Prairie Island Nuclear Generating Plant  
1717 Wakonade Drive East  
Welch, MN 55089

Prairie Island Nuclear Generating Plant Units 1 and 2  
Dockets 50-282 and 50-306  
Renewed License Nos. DPR-42 and DPR-60

License Amendment Request to Adopt NFPA 805 Performance-Based Standard for Fire Protection for Light Water Reactors – Response to Request for Additional Information (TAC Nos. ME9734 and ME9735)

Response to Requests for Additional Information (RAIs)  
Regarding the License Amendment Request to  
Adopt National Fire Protection Association (NFPA) Standard 805  
at Prairie Island Nuclear Generating Plant Units 1 and 2

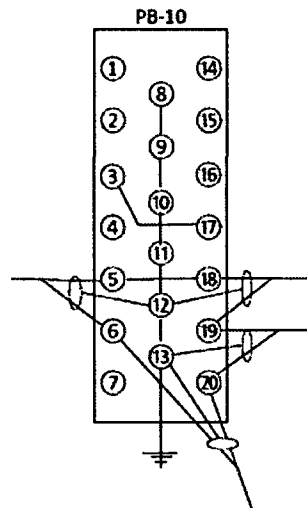
*Please describe the analysis method used to determine the failure mode is incredible and provide an example of the types of instruments that would be analyzed using this method.*

A. 2X #6AWG, 11/0192" T.C., BIW -  
HI (CSPE) INSULATION. O.D. 0.110  
B. BIW GLASS FILLERS  
C. BIW T-92 TAPE  
D. #36AWG TC SHIELD  
E. BIW T-91 FIRE-RESISTANT  
BINDER TAPES  
F. BIW BUC CSPE (BOSTRAD 7)  
JETKET

- a. Example: The block diagram directly below demonstrates a typical shield termination scheme for the plant. Shields are continuous and tied to ground.

Unit 1 RHR Suction Valves

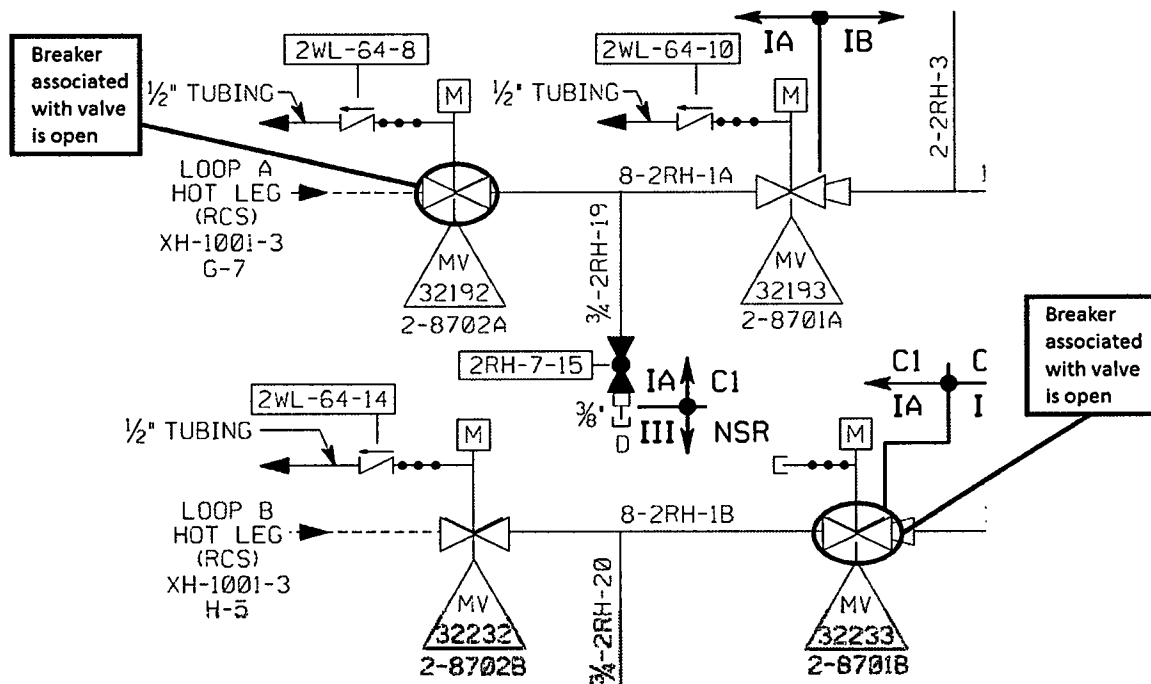
*Provide a description of any actions being credited to minimize the impact of fire-induced spurious actuations on power operated valves (e.g., air-operated valves and motor-operated valves) during NPO (e.g., pre-fire rack-out, actuation of/or pinning of valves, and isolation of air supplies).*

- a. During NPO modes, there are four RHR suction valves in each unit where spurious actuations could impact decay heat removal, as shown in the diagrams below. A pre-fire action is taken prior to entering higher risk evolutions to tag open the breakers associated with two of the four RHR suction valves, per procedures 1C1.3-M5 and 2C1.3-M5, "Unit 1 (2) Shutdown to Mode 5", for each unit, MV-32164 (Unit 1), MV-32231 (Unit 1), MV-32192 (Unit 2), and MV-32233 (Unit 2) during shutdown cooling, mode 5, to minimize the impact of fire-induced spurious actuations of RHR suction valves from the RCS Hot Leg. During higher risk evolutions PINGP will use administrative controls listed on page D-10 of the LAR, to minimize the risk of potential fire damage that could impact operation of the following RHR suction valves: MV-32165, MV-32230, MV-32193, and MV-32232.
